OFFICE / WAREHOUSE

PROJECT LOCATION:
**LOTS 1-4
4TH & SARAZIN ST.
SHAKOPEE, MN 55379**

REVIEW SET	10-27-16
BUDGET SET	3-7-17
PRECAST SET	4-11-17
PERMIT SET	5-18-17
FABCON RFI #1 & #2	5-31-17
ADDITIONAL DETAILS	6-9-17
OWNERS COMMENTS	6-26-17
REVISION #1	7-14-17
REVISION #2	8-17-17
REVISION #3	8-30-17

COVER SHEET
SITE PLAN
A1.0

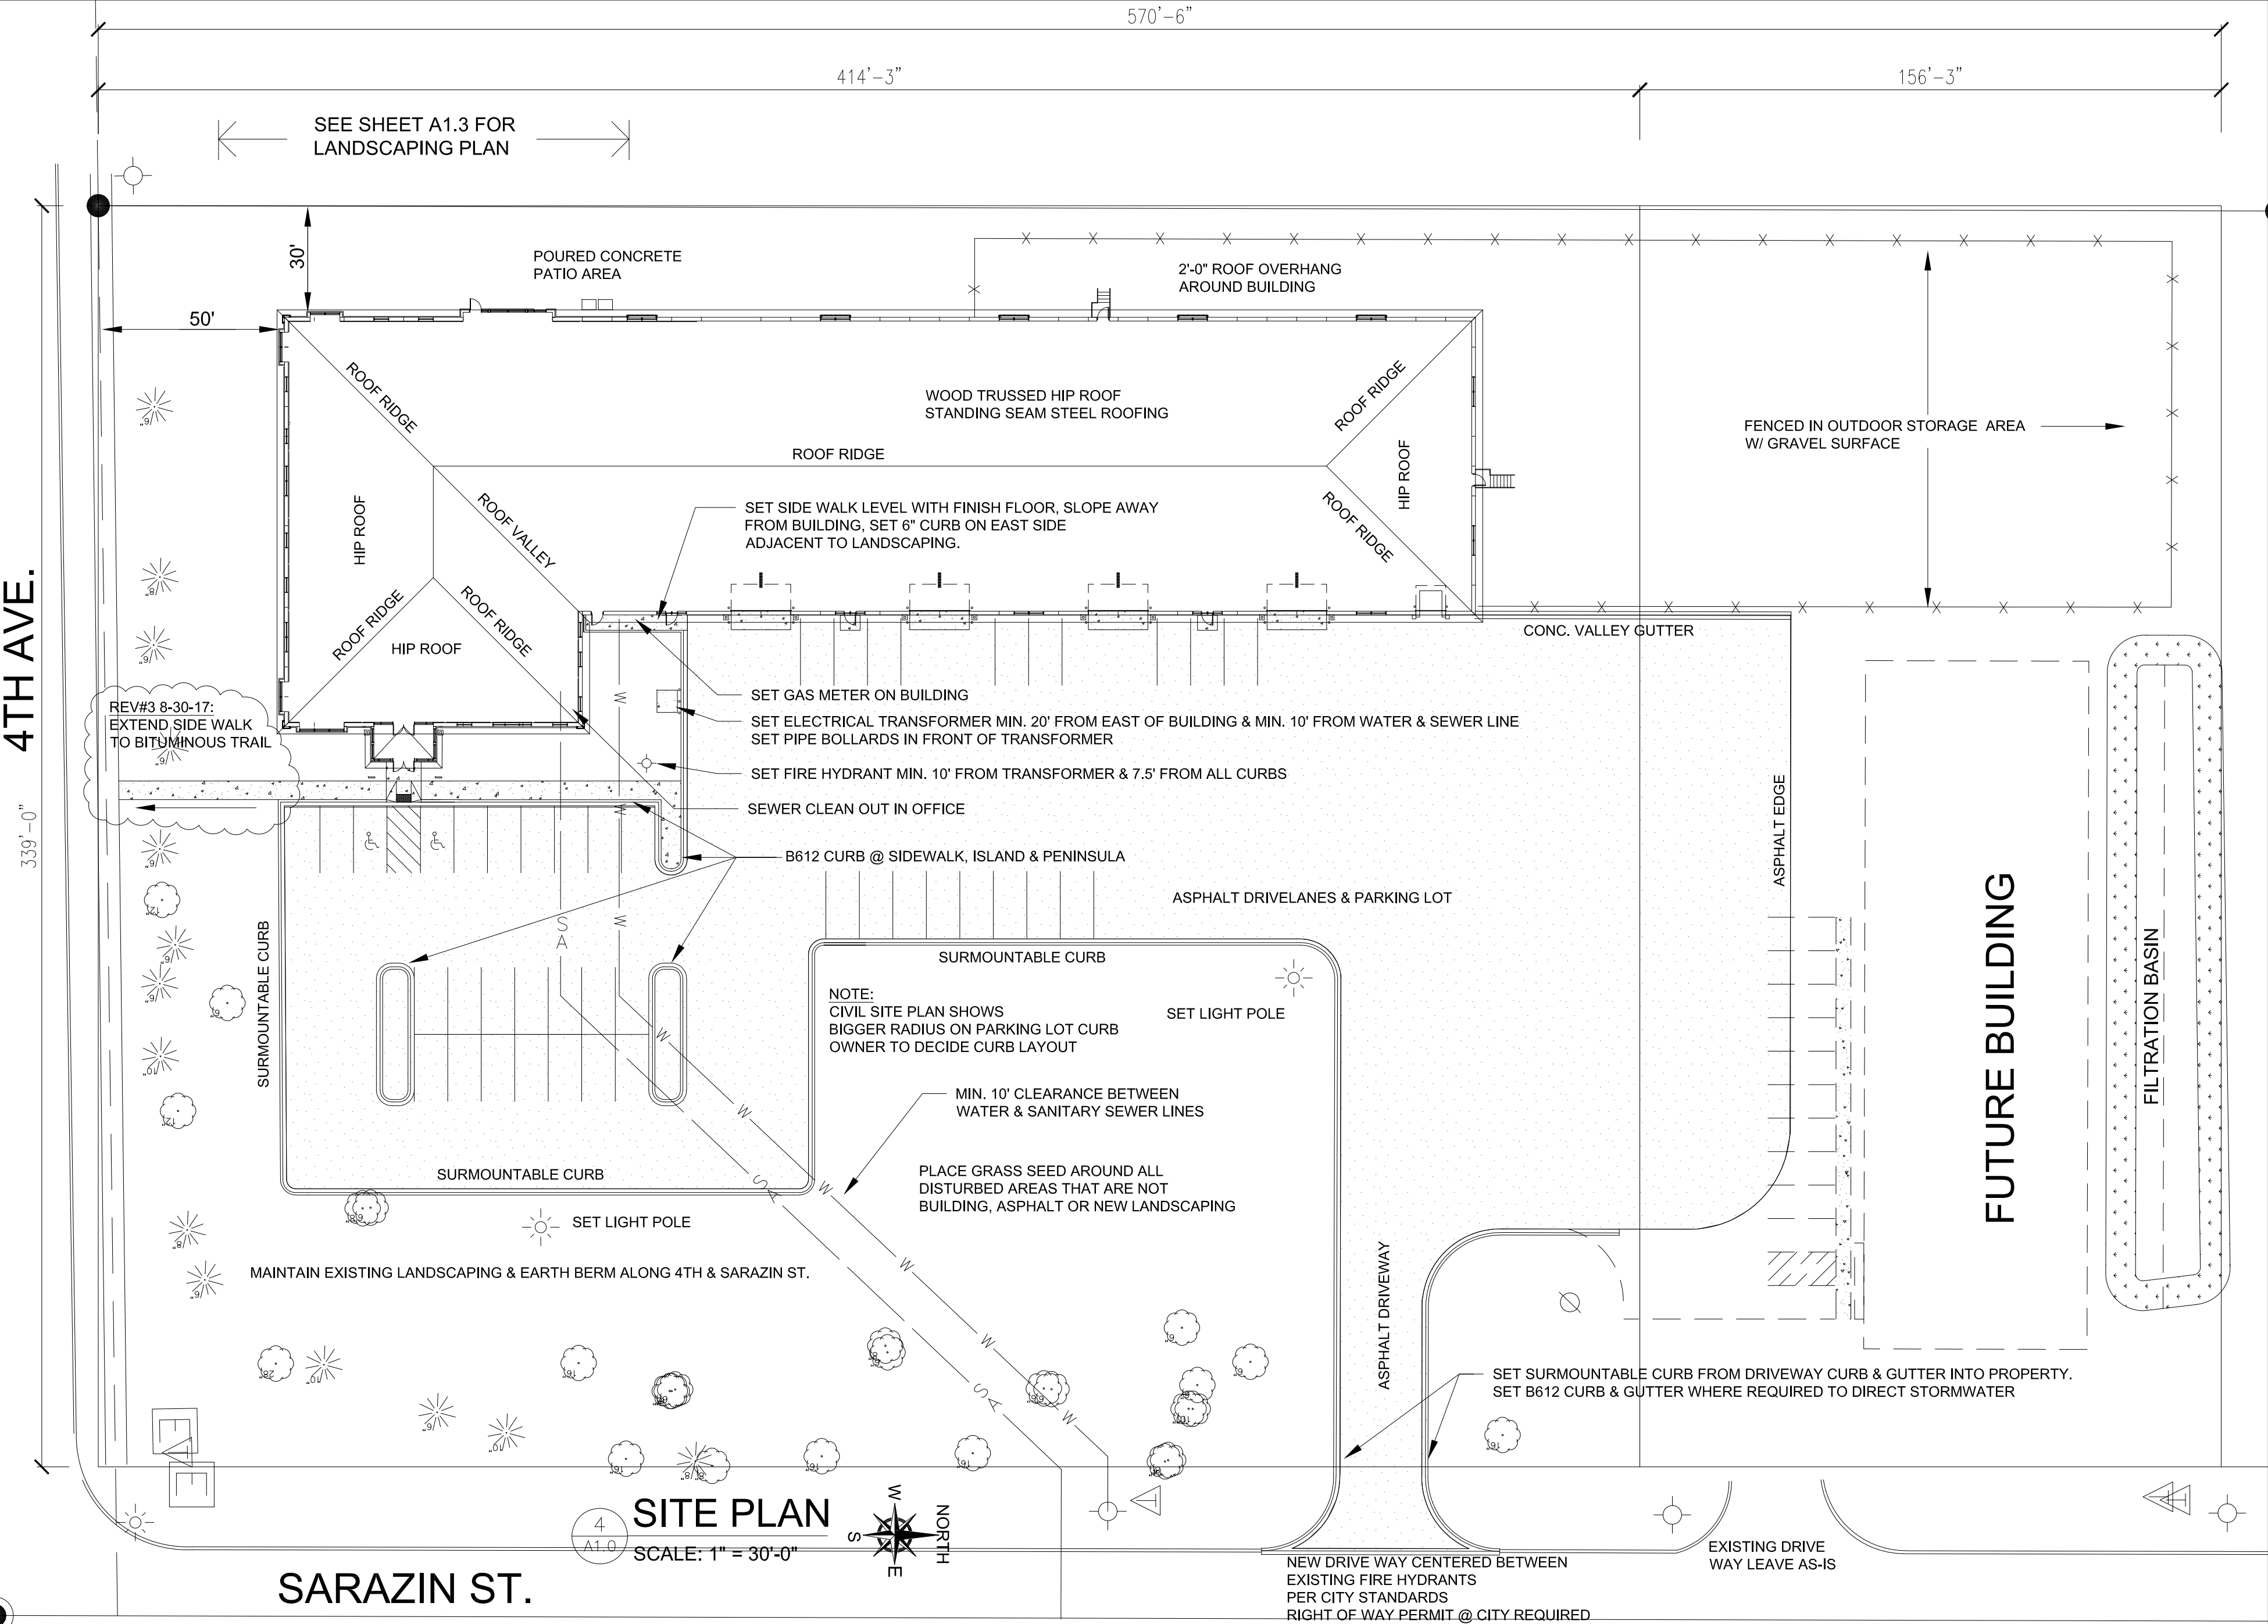
REV#1 7-14-17:
ADDITIONAL SITE INFORMATION ADDED

REV#2 8-17-17:
CHANGE CULTURED STONE TO NATURAL STONE ON EXTERIOR
CHANGE EXTERIOR WAINSCOT CAP TO BREAK METAL
ADD DIMS TO BOX OUT ROOF OVERHANGS
CHANGE AWNING FOYER & OVERHEAD DOOR COLUMN BASE
ADJUST FIRE HYDRANT AND TRANSFORMER PAD
TO MEET CLEARANCE REQUIREMENTS
CHANGE LOCATION FOR WATER INTO BUILDING & SEWER OUT

REV#3 8-30-17:
CITY COMMENTS
EXTEND SIDE WALK TO BITUMINOUS TRAIL
ONLY ARCH. SHEETS AFFECTED ARE A1.0 & A1.3
